Access Compliance Report Public Rights-of-Way (Pedestrian Signals)

Main Street: AIROSO_ST Cross Street: CHIQUITA_CANYON_DR Location: SW

ADA ID: SGRK211130125116 Signal Type: One Push Button-Non APS Overall Compliance: No Severity Scores: BTN 1: 35 BTN 2: N/A No BTN: N/A

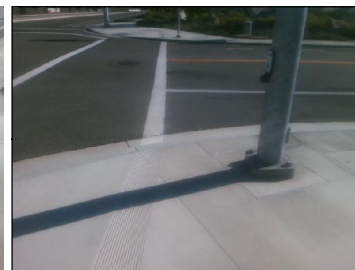
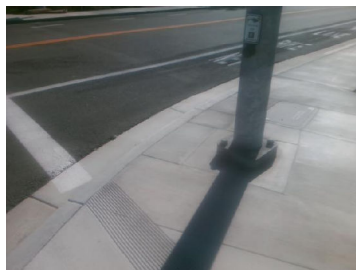
OC Std/PROW: R404.2, R404.3, MUTCD 4e.08

Possible Solutions: Replace Signal Push Button With APS Button. Remove and Replace Clear Space.
